# PLANNING & ZONING COMMISSION

**TO:** City of Peoria Planning & Zoning Commission  
**THRU:** Site Plan Review Board  
**FROM:** Shannon Techie, Senior Urban Planner  
**DATE:** November 9, 2015  
**CASE NO:** PZ 15-48

**SUBJECT:** Public Hearing on the request of Elza Ghantous of Elza Ghantous Realty, for Hatem and Ghassan Kattom, to obtain a Special Use for auto sales and repair in a Class C-1 (General Commercial) District for the property located at 2010 W. Forrest Hill Avenue (Parcel Identification Number 14-31-226-014), Peoria, Illinois. (Council District 2).

SITE ALTERATIONS  
FOR  
2010 FORREST HILL AVENUE

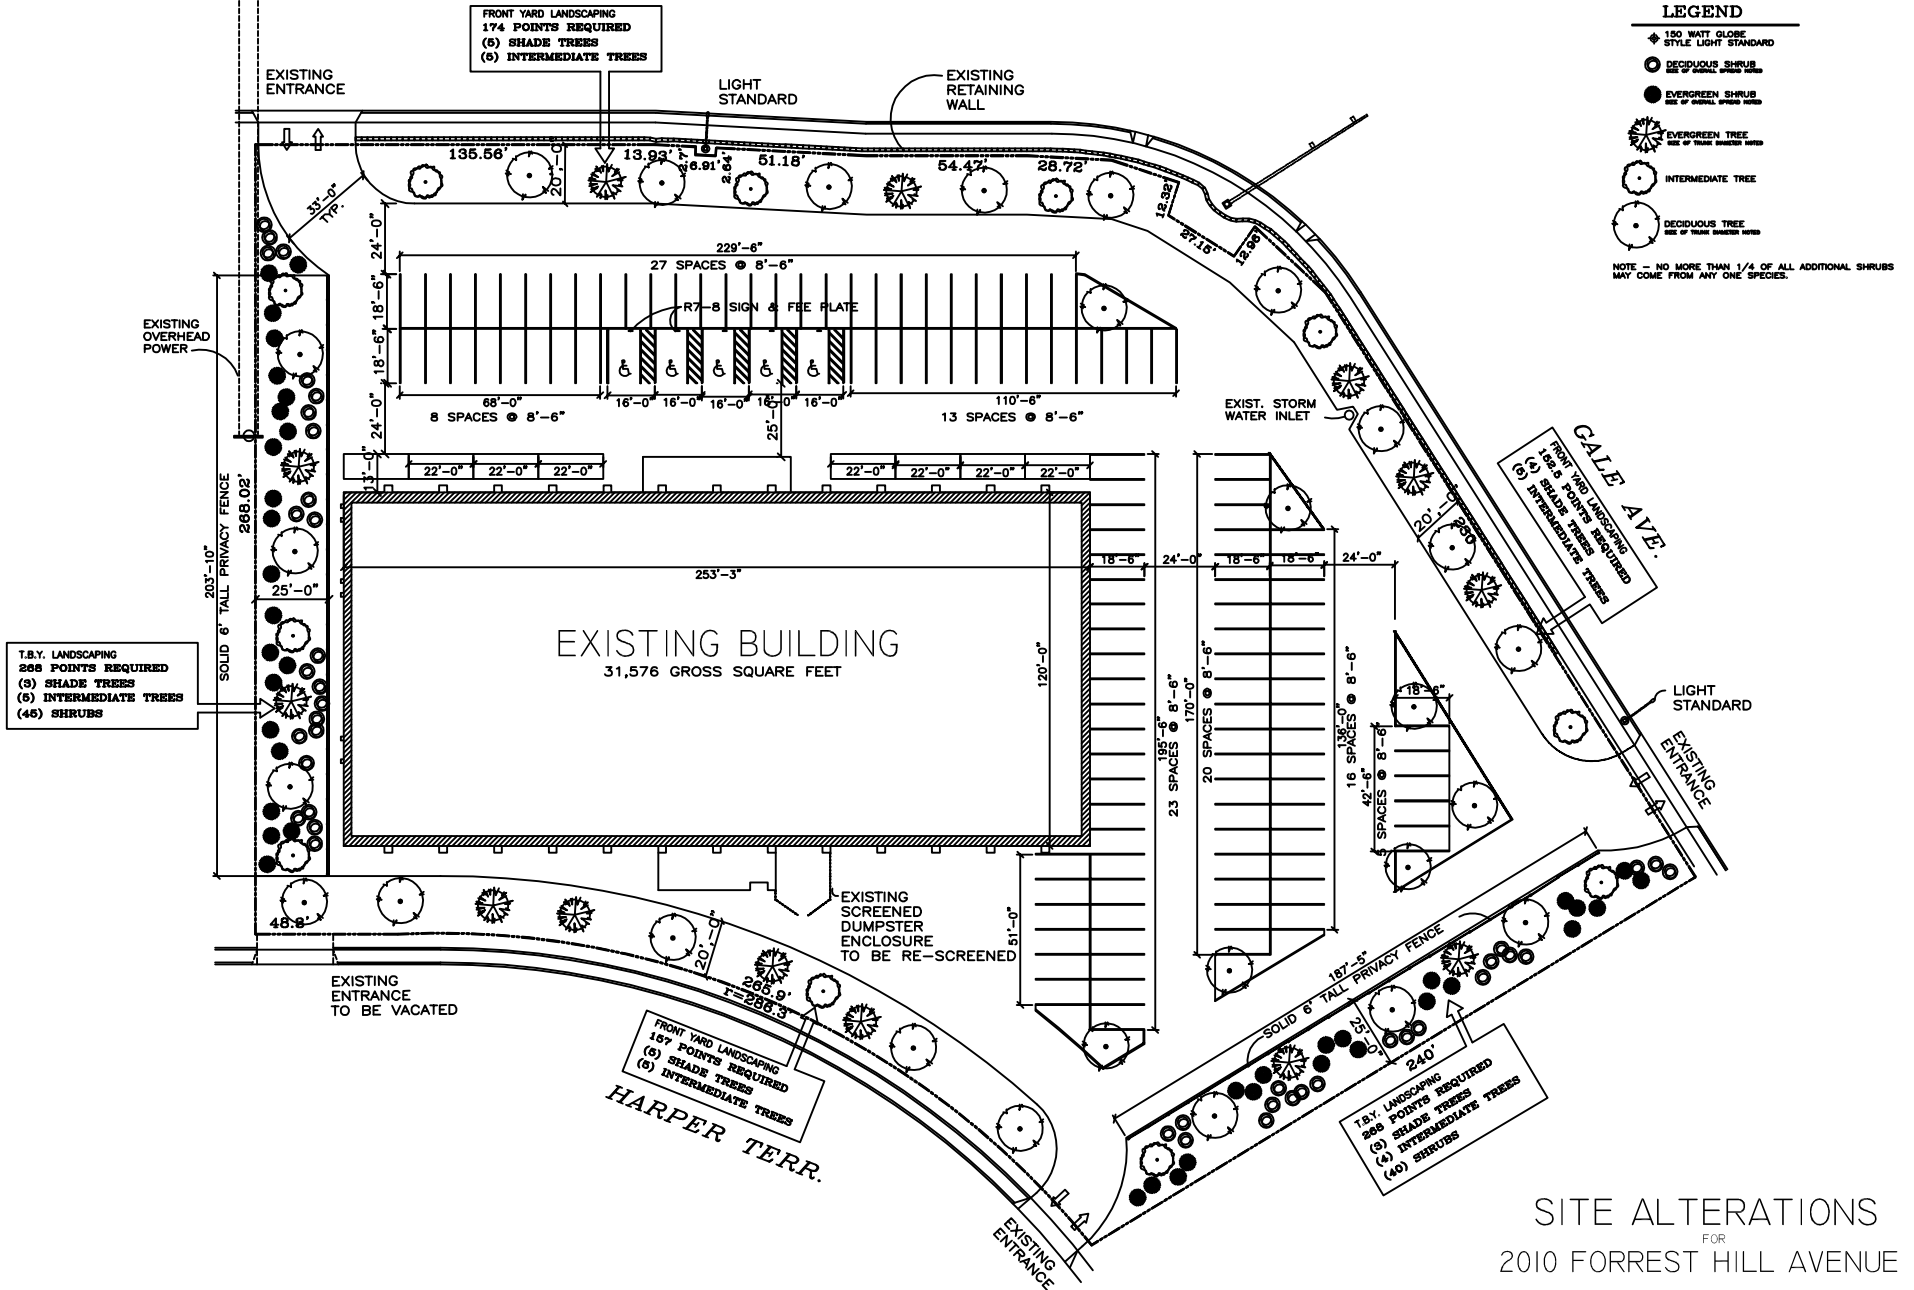
Front yard landscaping is required to meet Zoning Ordinance requirements along Harper Terrace, Gale Avenue, and Forrest Hill Avenue, with 157 landscape points required along Harper Terrace, 174 points along Forrest Hill Avenue, and 152.5 points along Gale Avenue. All front yard landscape is required to be from the tree classification. Front yard landscaping meets ordinance requirements as shown on the site plan provided.

Transitional Buffer Yard Landscaping: A 25 foot deep transitional buffer yard is required along with west side of the property and long the southeast boundary of the property, as both areas abut residentially zoned property. 288 points of landscaping are required in the TBY on the west property boundary and 268 points are required in the TBY on the southeast property boundary. The transitional buffer yard as proposed meets Zoning Ordinance requirements.

Screening of the Activity Area: Per Appendix B, Article 16.4.(7), the parking areas that are adjacent to a required TBY are required to be visually screened with a fence, wall, berm, planting or combination thereof which achieves a substantially solid six-foot visual barrier. If a fence or wall is used to meet this requirement it must be located between the activity area and the TBY. A 6 foot tall fence has been shown between the parking lot and the required transitional buffer yard, which meets Zoning Ordinance requirements.

Parking Lot Landscaping: 130 landscape points are required for the parking area, in the form of shade trees. The site plan meets Zoning Ordinance requirements, in that 7 shade trees are proposed within the parking lot.

A dumpster enclosure currently exists on the site, at the back of the building along Harper Terrace; however, the enclosure is in disrepair and will not fully screen the refuse area as required. The site plans notes that refuse area will be screened per Zoning Ordinance requirements.

There is an existing freestanding sign on the site that appears to meet Zoning Ordinance requirements for setback, area, and height. If the sign is to remain, a revised site plan should be provided showing the location of the freestanding sign, with the setback from the property line labeled on the site plan. No sign information was provided by the petitioner. Any new signs must meet Zoning Ordinance requirements and require a separate application.

2. Auto Repair	All auto repair must take place within an enclosed building; no auto repair must occur on the exterior of the building.	Support
3. Signs	If the existing freestanding sign is going to remain on the site, a revised site plan is required showing that the sign meets Zoning Ordinance requirements for setback, area, and height. Any non-conforming signs must be removed as part of this approval and any new signs require a separate application.	Support
